Ohio's July 16, 2014 Request for a Comment Period Extensions

Issue Paper: Building Block #1 Heat Rate Improvements for Coal-Fired Power Plants

The Electric Power Research Institute, Inc. (EPRI) respectfully submits the enclosed comments¹ on the U.S. Environmental Protection Agency's (EPA's) proposed rule titled Carbon Pollution Emission Guidelines for Existing Stationary Sources: Electric Utility Generating Units. EPRI thanks the EPA for the opportunity to comment on this proposed rule.

Figure 1: Natural gas price relationship to NGCC unit capacity factors

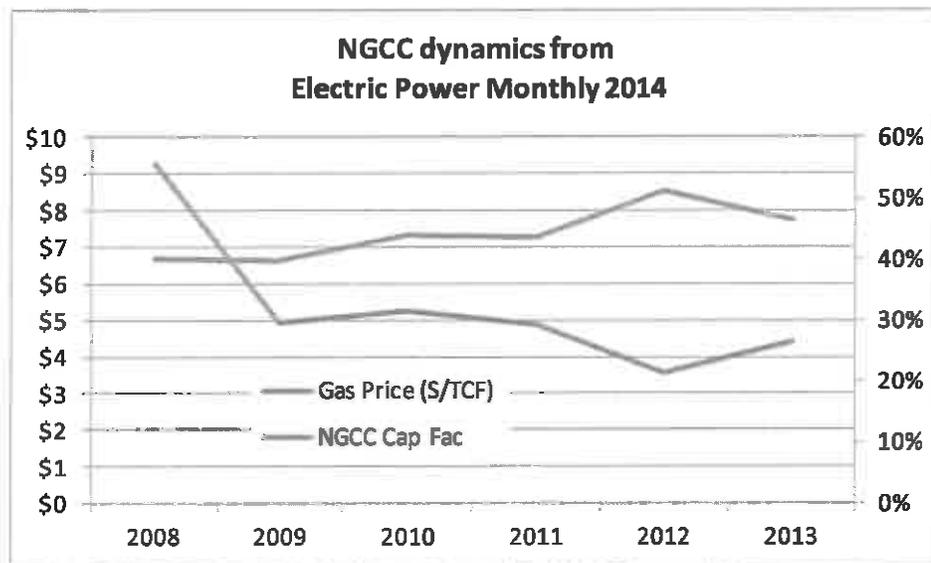
over time in *the relative prices of natural gas and coal*” (emphasis added, p. 175). However, history suggests that NGCC capacity factor is a sensitive function of natural gas prices; therefore, the assumption of high future NGCC capacity factors could be invalid if significant natural gas price volatility and increases were to be experienced in the future. This historical relationship is illustrated in Figure 1 by showing the trends in both the price of natural gas and resulting NGCC capacity factors from 2008 to 2013 from the most current U.S. Energy Information Administration (EIA) Electric Power Monthly.²¹

1
2
3
4
5
6 **Figure 1. Areas Projected to Experience Health Benefits under the Selected NAAQS of $12 \mu\text{g}/\text{m}^3$ in**
7 **the $\text{PM}_{2.5}$ NAAQS RIA (459-1033 avoided premature deaths, rounded to nearest death)**

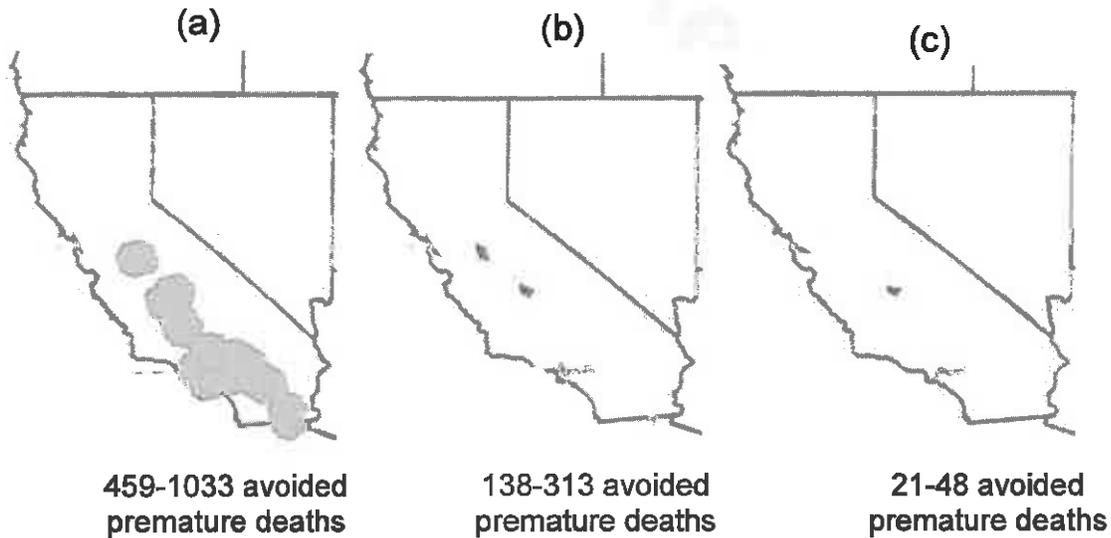
23 Whether the particular probability weights used in this analysis are correct, or should be refined,
24 the point of this analysis is that the RIA's benefits estimates are extremely sensitive in the
25 downward direction to any such weighting.
26
27
28
29

30 Geographical representation of where these health benefits are expected to occur is also
31 interesting to explore. The reductions in premature mortality were calculated only for areas that
32 were within 50 km of a monitor that the RIA's air quality analysis projected would not attain
33 each alternative standard under baseline conditions in the year 2020. Figure 1 shows the areas in
34 which the RIA's estimate of 460-1000 avoided premature deaths occur. It is notable that all of
35 those benefits occur in California, a point discussed later. Figure 2 zooms in on California to
36 show: (a) the areas in Figure 1 where benefits are attributed to reductions in $\text{PM}_{2.5}$ at any level;
37 (b) the more limited areas projected to experience a health benefit when only reductions in $\text{PM}_{2.5}$
38 that start above the $12 \mu\text{g}/\text{m}^3$ NAAQS are considered; and (c) the even more limited areas if a 1

39 $\mu\text{g}/\text{m}^3$ margin of safety is assumed to be associated with the selected standard of $12 \mu\text{g}/\text{m}^3$. That
40 is, Figure 2(c) only gives weight to risks below $13 \mu\text{g}/\text{m}^3$.
41
42
43
44
45
46
47
48
49
50
51
52
53
54
55
56
57
58
59
60
